DEPARTMENT OF THE NAVY
NAVAL AMPHIBIOUS BASE LITTLE CREEK
2600 TARAWA COURT SUITE 100
NORFOLK, VIRGINIA 23521-3229

Subj: COMMENTS ON THE DRAFT FEASIBILITY STUDY, SITE 7

Encl: (1) Detailed Comments List
(2) Site 7 Habitat Restoration Preliminary Scope

1. Enclosures (1) and (2) are forwarded for inclusion in the final comments list on the Draft Feasibility Study, Site 7 prepared by Foster Wheeler, Inc.

Naval Amphibious Base Little Creek		
SITE PLAN PROPOSED JOGGING PATH AND NATURE TRAIL		
DRAWN BY: DFT	SCALE: 1" = 400'	DATE: 9-26-95

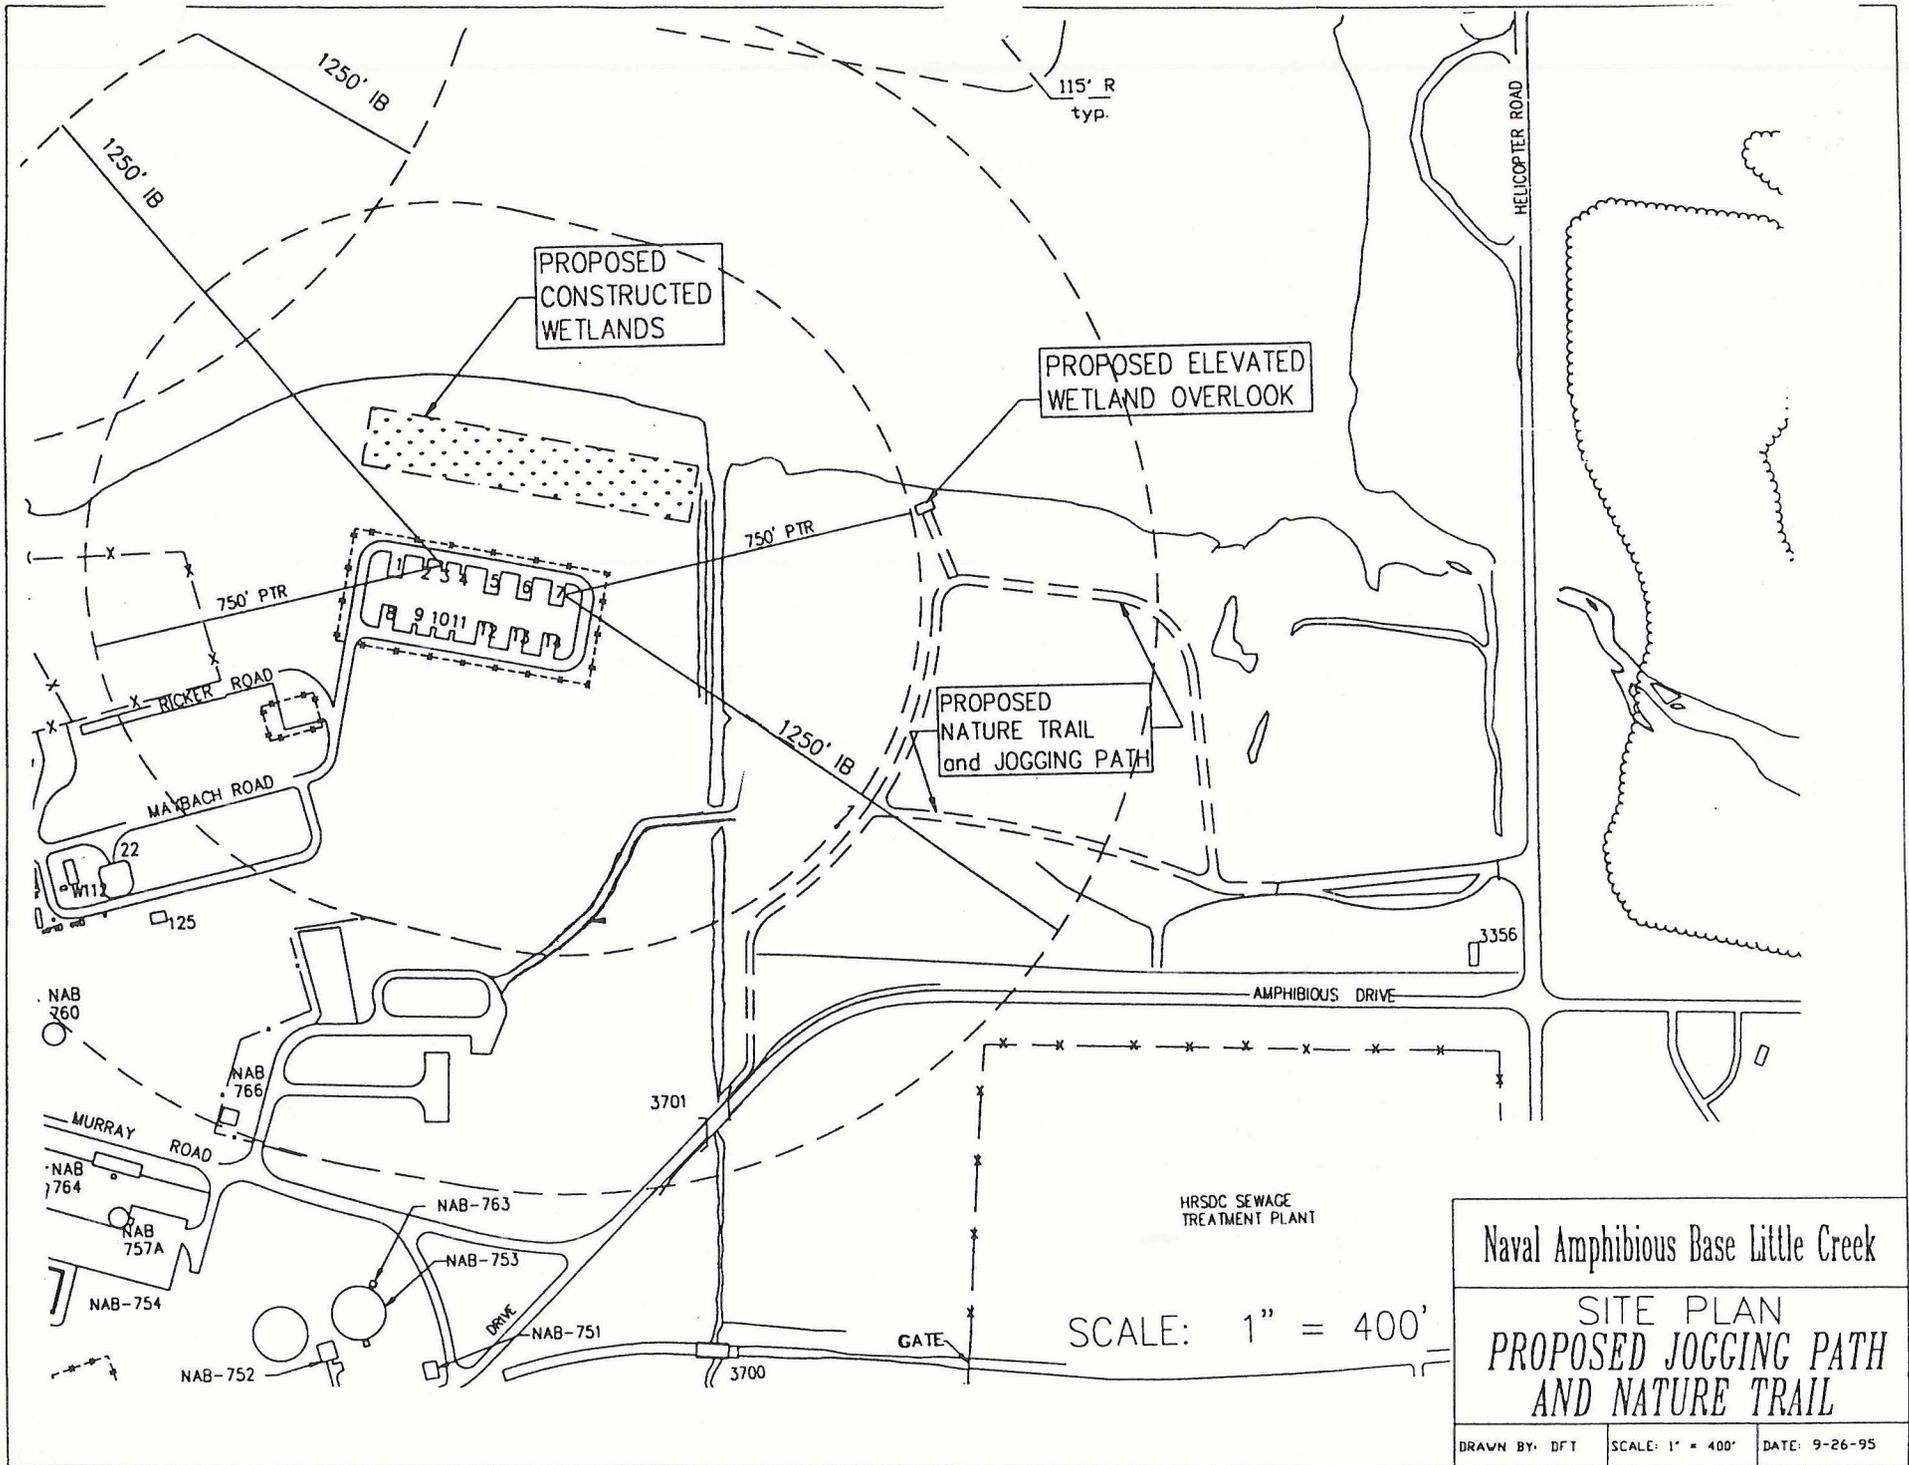
The purpose of the habitat restoration is to enhance the land-use capabilities of the site for both wildlife habitat and outdoor recreation/exercise while maintaining long-range management of the landfill. Since studies have shown that many former landfills do not undergo the usual process of woodland progression (grasses to shrubs to trees to mature forests), the intent of the project is to accelerate the process of natural succession while providing the public with an area to enjoy. The site has already been covered with six inches of soil and seeded with clovergrass. Edges of the site are naturally revegetating with native species of grasses, shrubs and trees. Wetlands are also on the edges of the site due to its proximity to Little Creek Cove. A 10 to 12 acre open area in the middle of the site is suitable for enhancement.

The proposed enhancement would be designed by a landscape architect who would work on a team with Virginia Department of Game and Inland Fisheries biologists, the Virginia Native Plant Society, NAB Natural Resources staff and other experts in landfill restoration/reclamation. The wildlife habitat will be diverse, with both native and naturalized plant species utilized which have high wildlife values for both feeding and nesting but are low maintenance. Five distinct habitat "cells" may be designed to attract a range of insects, amphibians, birds and mammals. These cells will mimic various stages of natural succession. Another option would be to mow the clovergrass in alternating years to maintain the area as a field. Fauna will continue to benefit from this low stage succession area for feeding.

The recreation/exercise area will include a jogging trail with loops to include the habitat cells. Turnouts will be designed for educational signs. Raised walking/viewing platforms will be used in the wetlands areas. Interactive stations could also be used for the habitats; one such example would be a bird viewing register and guide for visitors to log observations. The cells will be spaced so as to allow future additions of paths, educational signs etc.

To protect the landfill, visitors of the habitat area will not be allowed to drive their vehicles into the site. Parking will be allowed along Helicopter Road, outside of the site. Also, signs will emphasize that the site is a former landfill, and therefore visitors will be instructed to stay on the paths provided. With the current soil cover and these site restrictions, risks related to dermal contact or ingestion of the soil will be mitigated. Also, city regulations require that paths be a minimum of 50 feet from any waterbody or wetlands area, therefore visitors will not have ready access to surface water.
